TAOS AT THE TRAILS UNIT 2
GRADING & DRAINAGE PLAN

City Project No.	Zone Map No.	Sheet	Of
730089	C-9-Z	5	19

TAOS AT THE TRAILS UNIT 2
GRADING & DRAINAGE PLAN

TAOS UNIT 1 at the TRAILS
POND K GRADING PLAN

TAOS AT THE TRAILS UNIT 2
GRADING & DRAINAGE PLAN

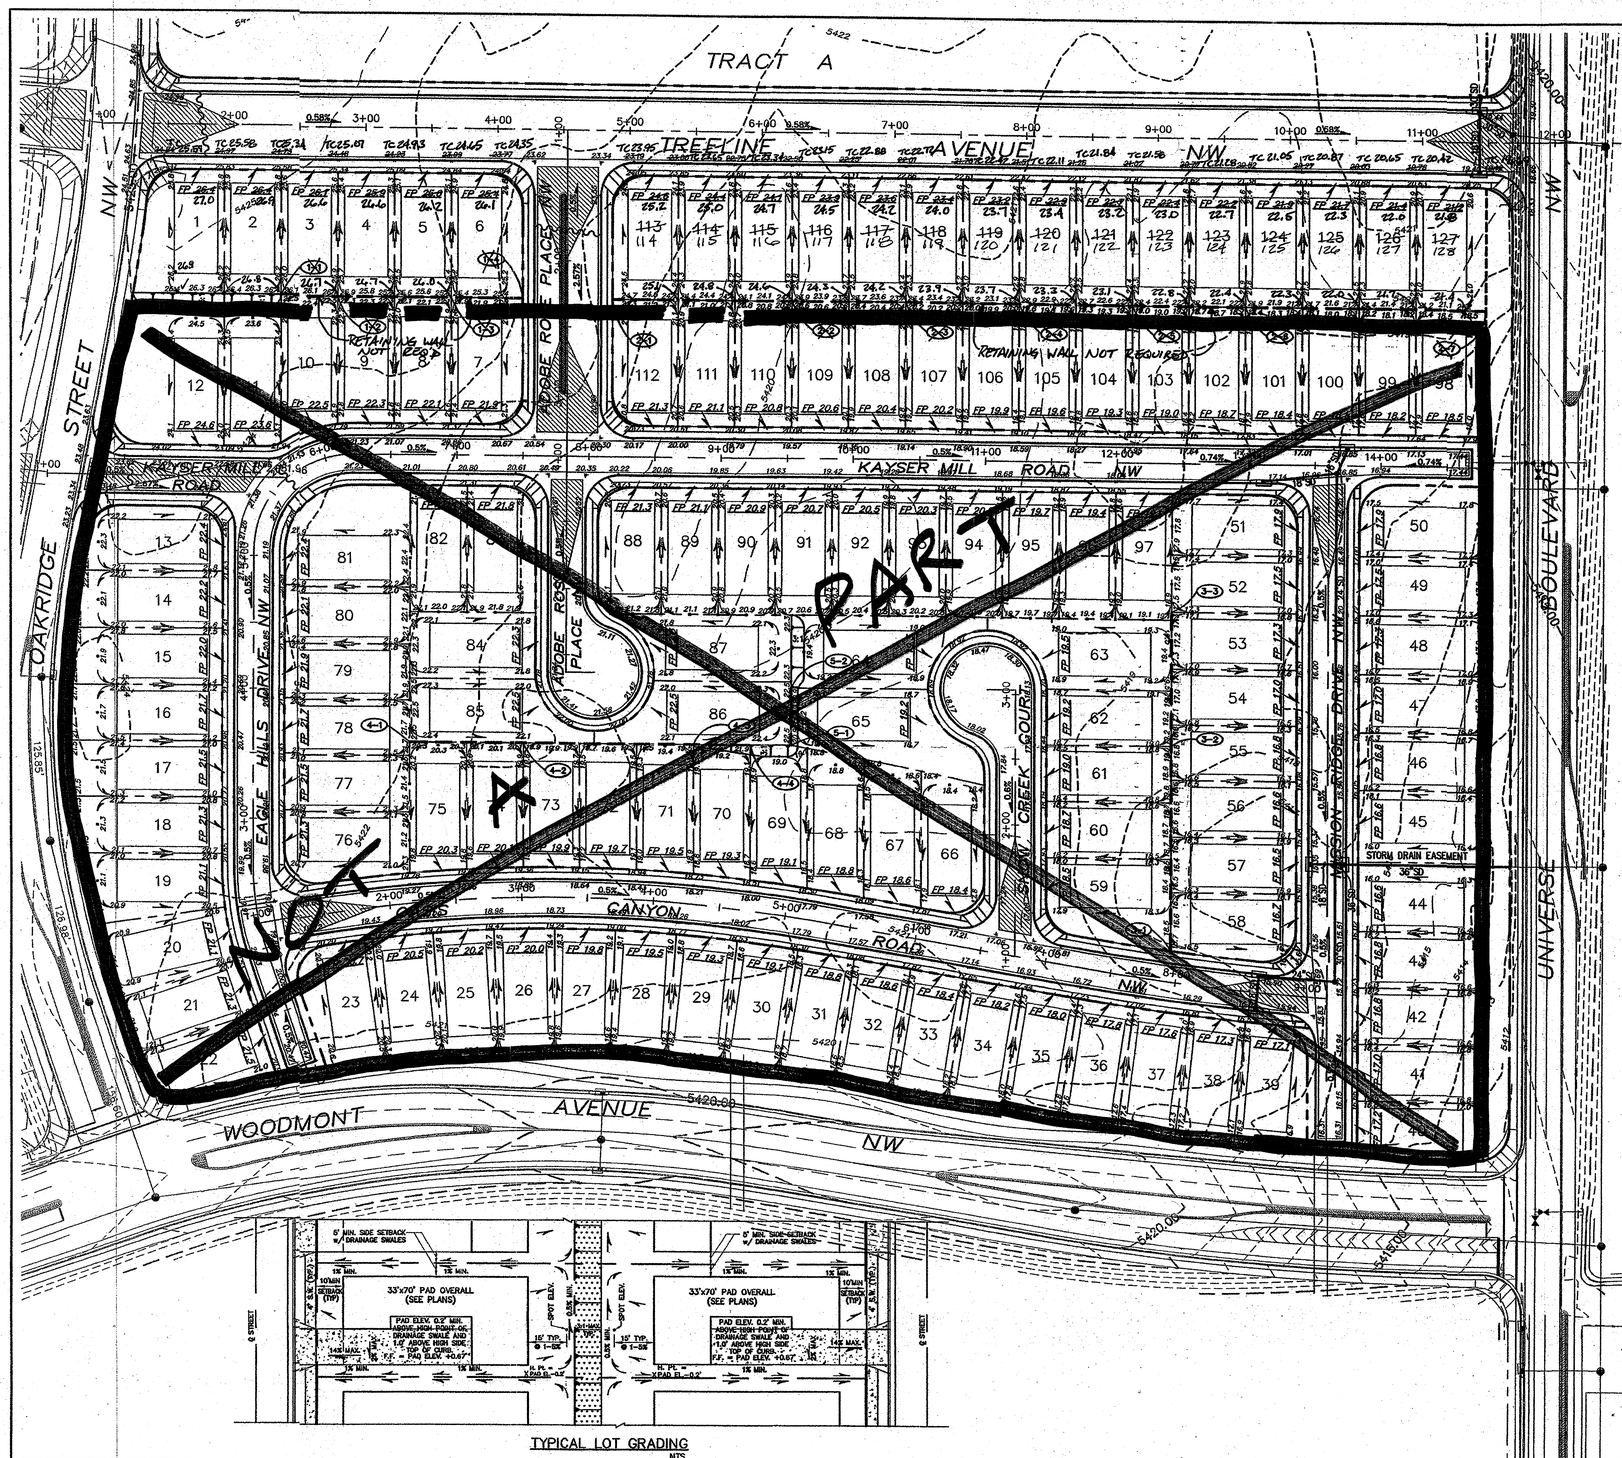
WALL POINT	TOP OF WALL ELEV	TOP OF FOOTING ELEV	WALL HEIGHT (FT)	APPROX. WALL LENGTH (FT)
1-1	26.00	22.00		
1-2	26.00/~~25.00~~	22.00/~~21.33~~	4.00	43
1-3	25.00/~~25.33~~	21.33/~~21.33~~	4.66	86
1-4	25.33	21.33	4.00	54
2-1	24.67	20.67		
2-2	24.67/~~24.00~~	20.67/~~20.00~~	4.00	136
2-3	24.00/~~23.33~~	20.00/~~19.33~~	4.00	86
2-4	23.33/~~23.33~~	19.33/~~18.67~~	4.00	86
2-5	23.33/~~22.67~~	18.67/~~18.00~~	4.67	86
2-6	22.67/~~22.00~~	18.00/~~17.33~~	4.67	86
2-7	22.00	17.33	4.67	182
3-1	18.67	16.00		
3-2	18.67/19.33	16.00/16.00	2.67	156
3-3	18.67	16.00	3.33	103
4-1	22.67	19.33		
4-2	22.67/22.67	19.33/18.67	3.33	86
4-3	22.67	20.67	4.00	172
4-4	22.67	20.67	2.00	43
5-1	22.67	20.00		
5-2	22.67	20.00	2.67	44

THE RETAINING WALL ALONG THE REAR PROPERTY LINE FOR LOTS 3-6 AND 114-128 IS NOT REQUIRED DUE TO REDESIGN OF THE LOTS TO THE SOUTH AS PART OF THE TAOS UNIT 1 AT THE TRAILS DEVELOPMENT (DRB#1008797). THE REDESIGN OF THE LOTS RESULTED IN A REAR LOT LINE ELEVATION DIFFERENCE OF 2.0' OR LESS.

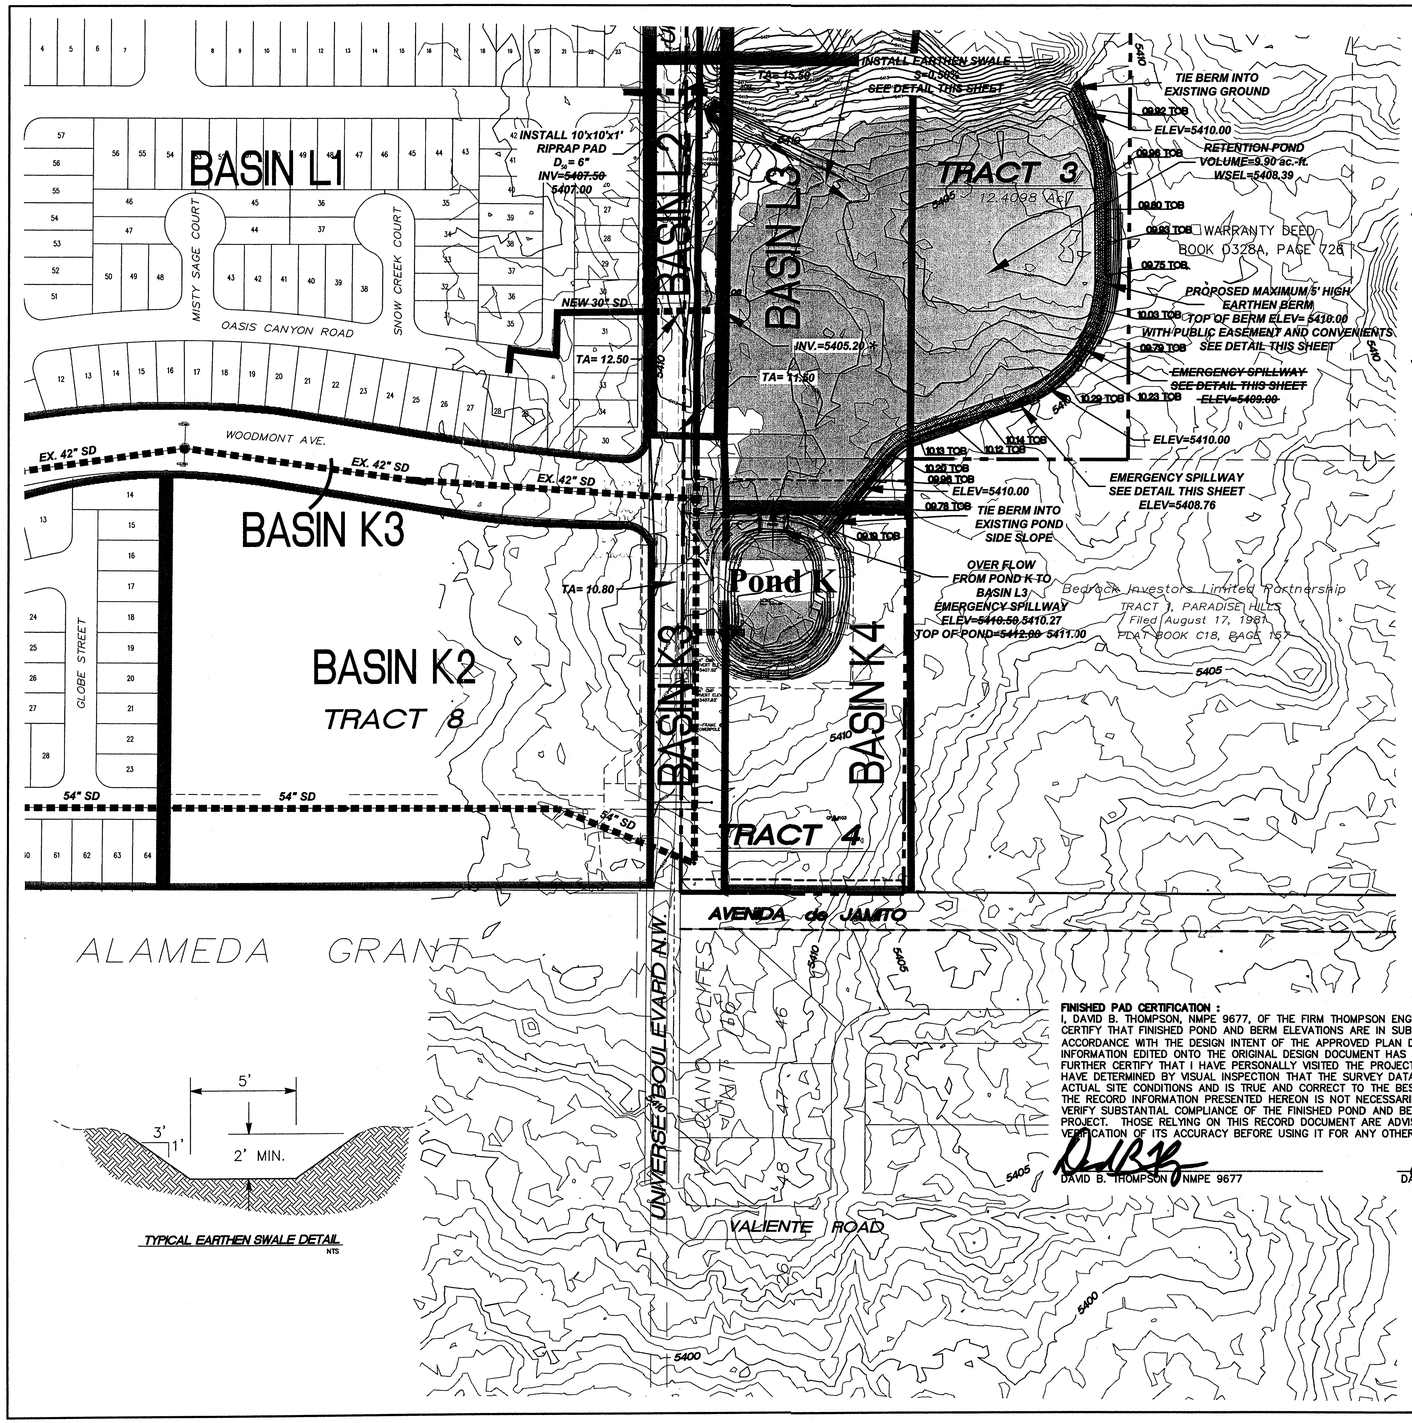
VOLUME REQUIRED = 9.90 ac.-ft.
VOLUME PRVIDED = ~~14.83~~ ac.-ft.
14.94

CANTATA AT THE TRAILS
POND J GRADING PLAN

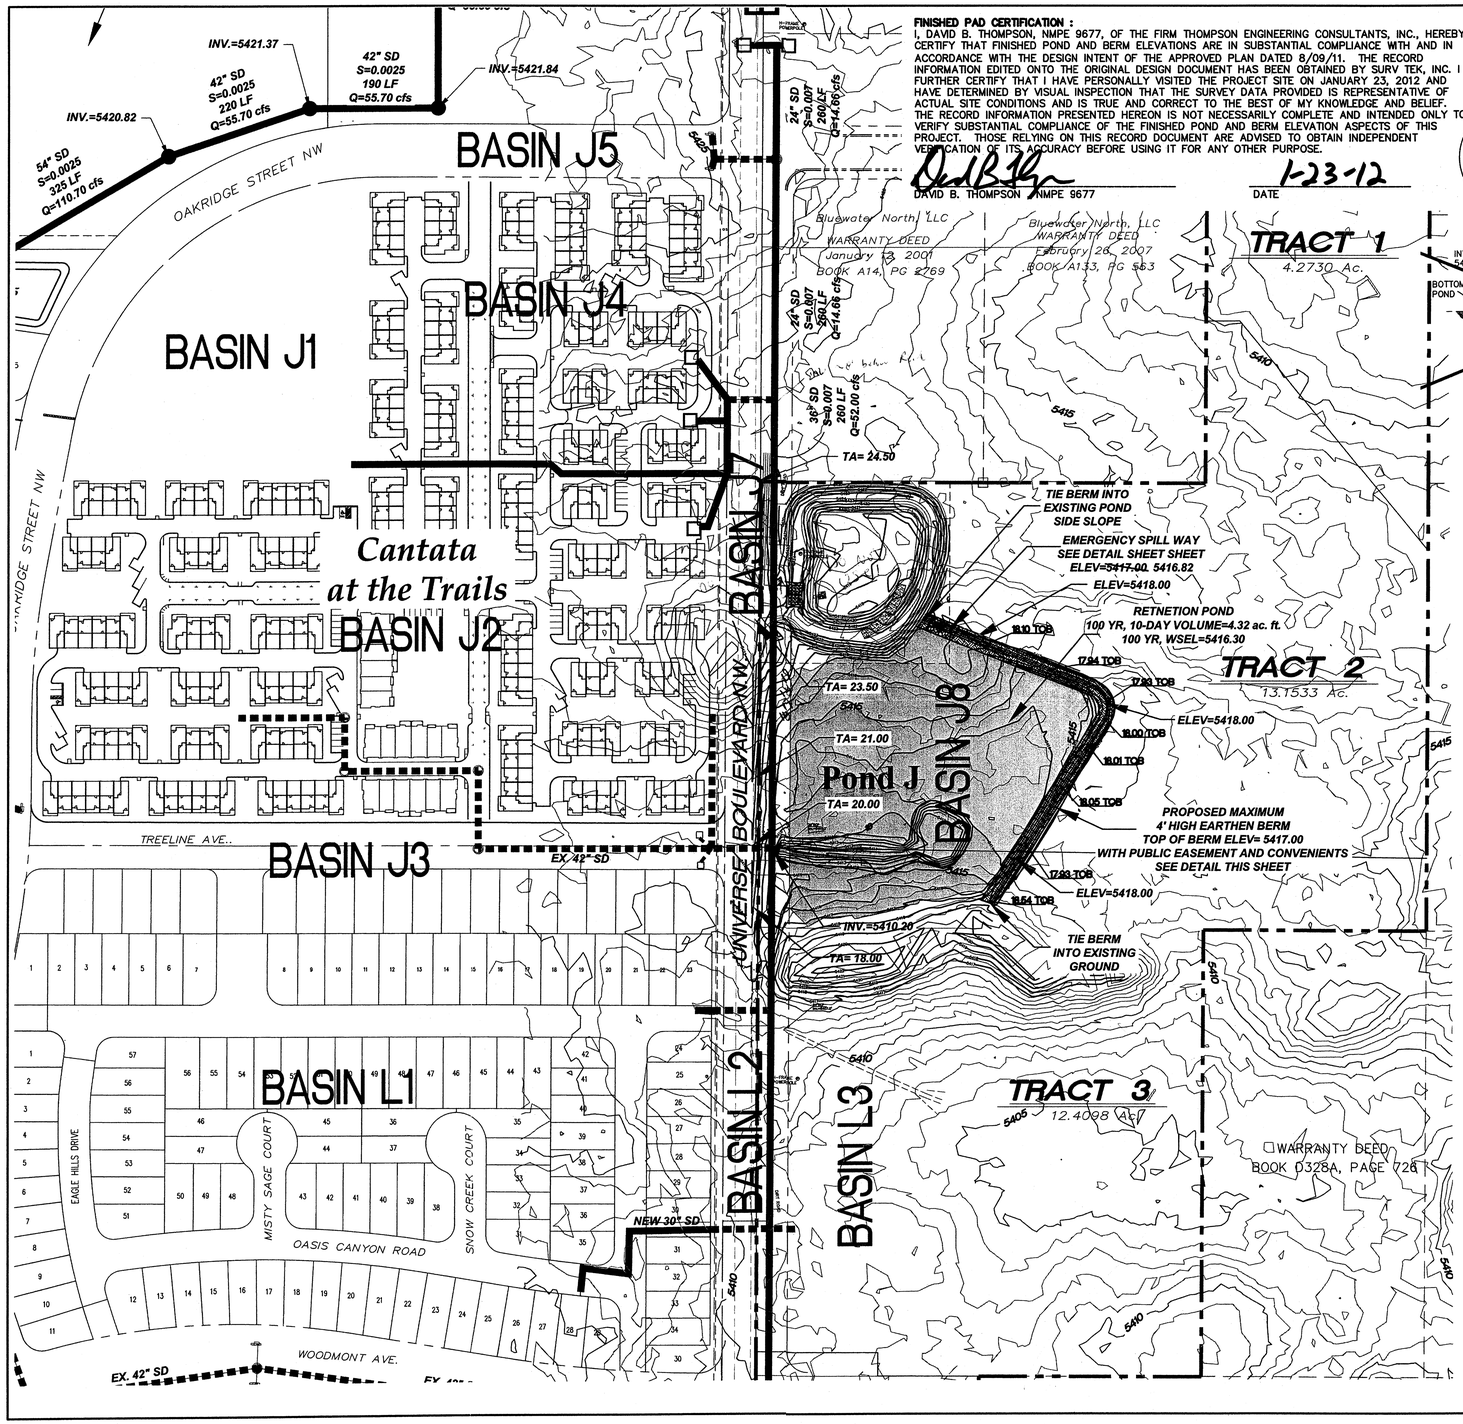
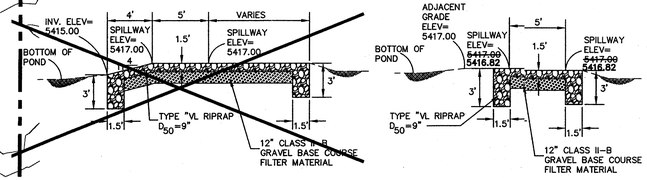
VOLUME REQUIRED = 4.38 ac.-ft.
VOLUME PRVIDED = ~~5.32~~ 8.90 ac.-ft.
